YSIDRO ADDITION TO WICHITA, SEDGWICK COUNTY, KANSAS

RE: SUB 2003-141 - One-Step Final Plat Ysidro Addition

CASE NUMBER: SUB 2003-141 -- YSIDRO ADDITION

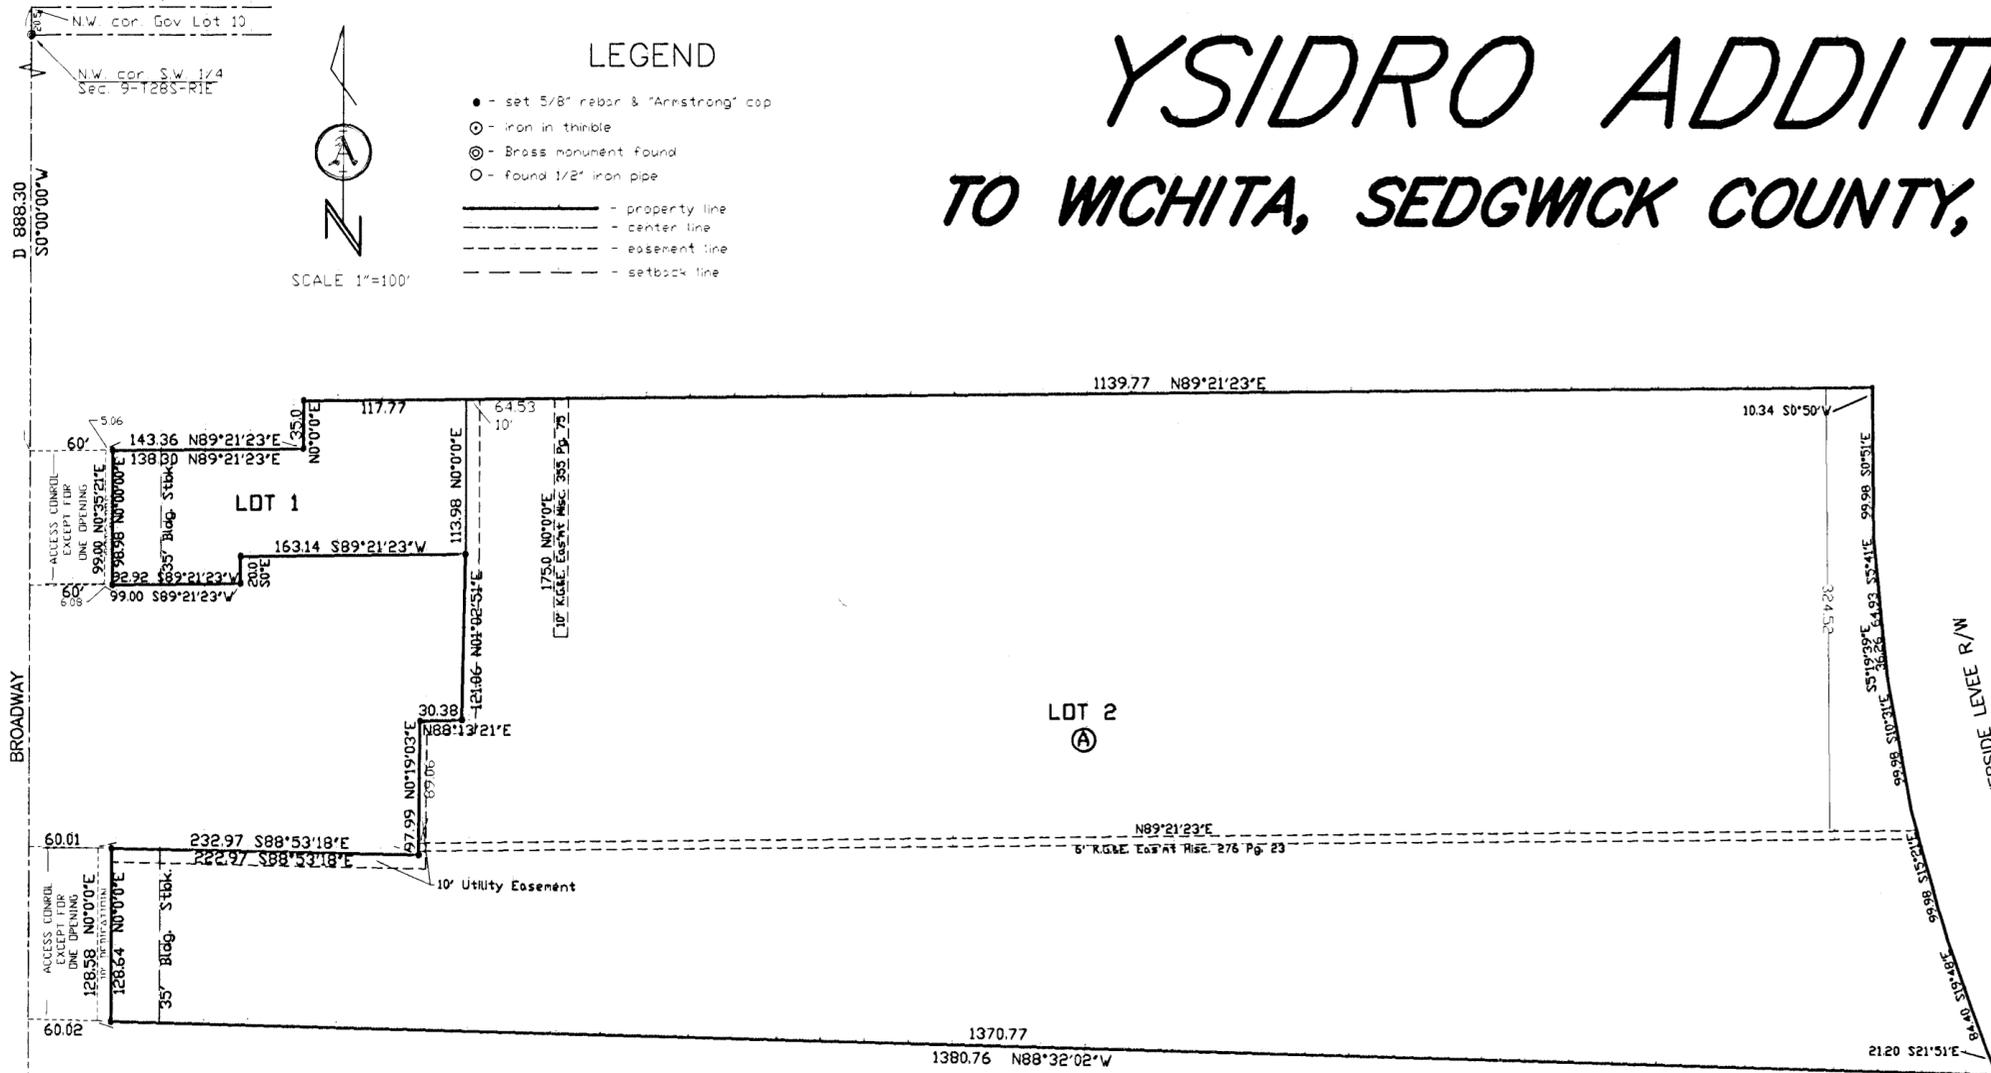
- E. **City Engineering** needs to comment on the status of the applicant's drainage plan. **A cross-lot drainage agreement and an off-site drainage agreement are needed.**

- F. Additional right of way dimensions are needed.
- G. The Riverside levee and Big Arkansas River need to be designated.
- H. The location of the established bank lines needs to be verified if located within the boundaries of the plat.

- I. A lot dimension on Lot 1 is needed.

- J. **Traffic Engineering** needs to comment on the access controls. The plat needs to denote access controls along Broadway on the face of the plat. The plat's text proposes one access opening for each lot. *Traffic Engineering has approved the access controls. A restrictive covenant shall be submitted that permits future cross-lot access with the abutting property owners to the north and south of Lots 1 and 2.*

- K. **Traffic Engineering** has requested additional right-of-way along Broadway. The Access Management Regulations requires a 60-ft half-street right-of-way width along urban arterials.

- N. The signature line for the City Clerk needs to be revised to reference "Karen Schofield".
- O. The year "2004" needs to replace "2003" within the signature blocks.

- Q. A Block shall be designated on the face of the plat as referenced in the plat's text.
- R. The plat's text shall include language that a drainage plan has been developed for the plat and that all drainage easements, rights-of-way, or reserves shall remain at established grades or as modified with the approval of the applicable City or County Engineer, and unobstructed to allow for the conveyance of stormwater.
